SERVICE BULLETIN
CHECKING OR REPLACEMENT
OF FLEXIBLE FUEL LINE
FOR ROTAX® ENGINE TYPE 912 (SERIES)
SB-912-054 UL

CHECKING OR REPLACEMENT OF FLEXIBLE FUEL LINE FOR ROTAX® ENGINE TYPE 912 (SERIES) SB-912-054

Checking or replacement of flexible fuel line for ROTAX® engine type 912 series.

Fig. 1

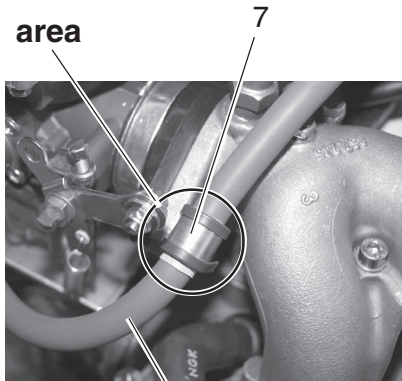
Visual inspection of the fuel line (1) in the area clamp (7) and both ends of the yellow protection cover. (see Fig. 1)

◆ **NOTE:** A possible crack can be observed by careful bending of the fuel line. If you notice cracks or porosity then you need to replace the fuel line in accordance section 3.1.2.

2. Install both cable clamp (7) in accordance with Fig.1 on the fuel line.

Fig. 2
08184

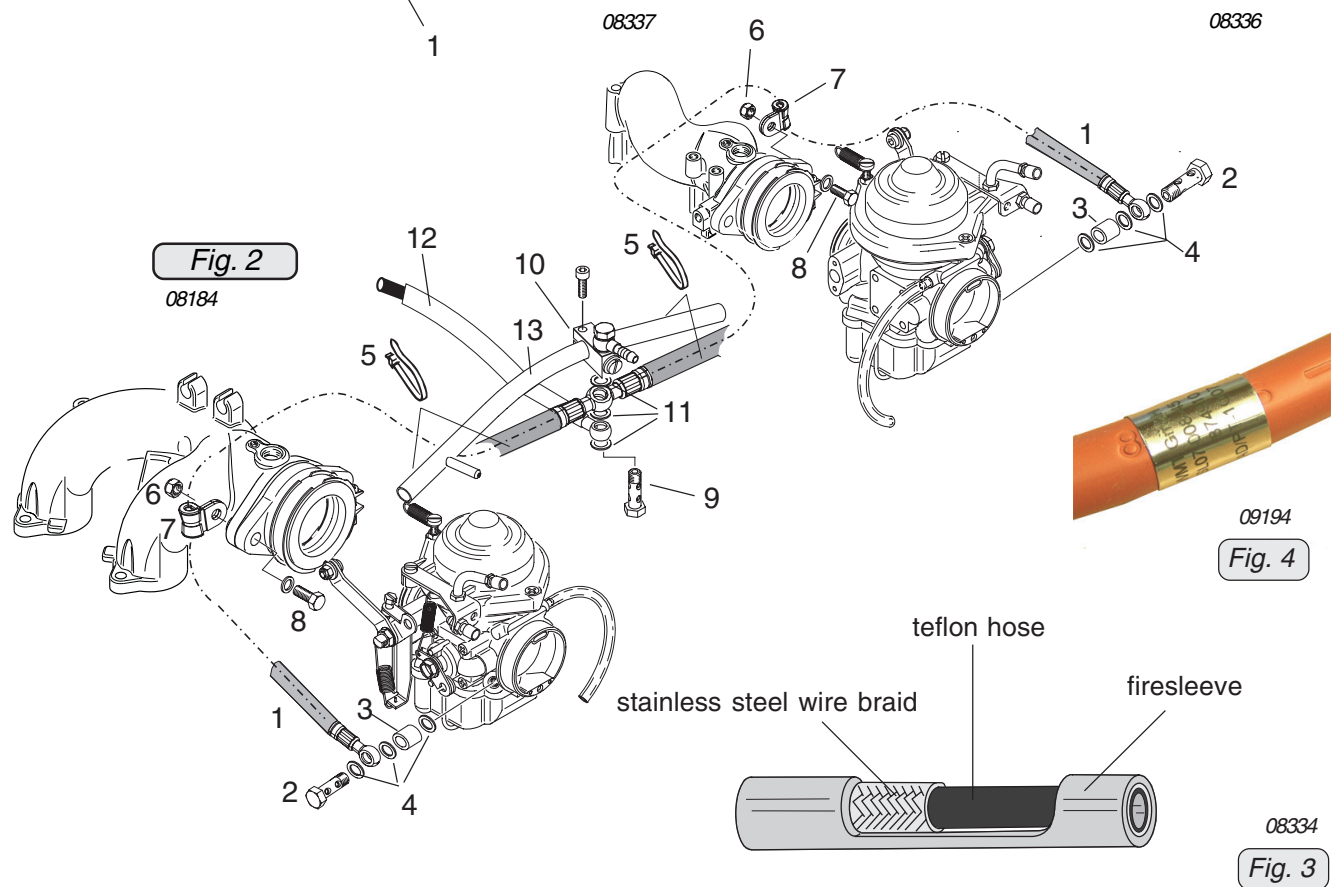
(see Fig. 2)

1. Unscrew the banjo bolt (2) with distance sleeve (3) and 3 gasket rings (4).

2. Cut the cable tie (5).

3. Remove hex. nuts M8 (6) together with clamp (7). Held in place by hex. screw (8).

4. Remove banjo bolt (9) from clamp block (10) together with 3 gasket rings (11).

◆ **NOTE:** The gasket rings 8x13 (4), used on the banjo bolt of the carburetor, are of different thickness compared to the gasket rings (11), used on the banjo bolt of the clamp block.

5. Remove the fuel line (12).

1. Install flexible fuel line (1 and 12) and the banjo bolt (9) with new sealing ring (11) on the clamp block (10). Tightening torque of banjo bolt (9) 10 Nm (90 in.lb). Check that the fuel lines are not under strain or tension.

3. Install the fuel line (1) with distance sleeve (3) and sealing ring (4) on the carburetors. Tightening torque of banjo bolt (2) 10 Nm (90 in.lb). Place cable clamp (7) into position.

4. For proper support. Install the clamp (7) and hex. nut M8 (6) with LOCTITE 221. Tightening torque of hex. nut (6) 15 Nm (133 in.lb).

◆ **NOTE:** Hold the hex. screw (8) when tightening hex. nut (6).

5. Fix the fuel line at the compensation tube with 2 cable ties (5).

08334
Fig. 3

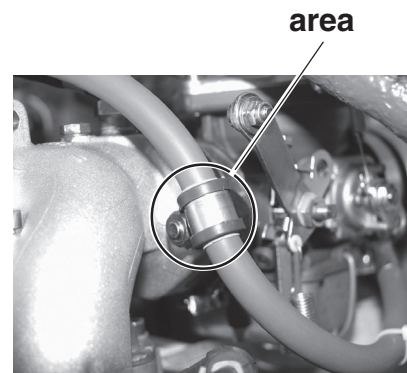
Due to a chemical reaction of the adhesive (in the area of the yellow position marks on the firesleeve) porosity and/or cracks on the firesleeve can occur.

Fuel leakage within this area is not an issue, as only the fireproof protection hose is affected and the fuel is routed in a wire braid reinforced teflon hose.

(see Fig. 3)
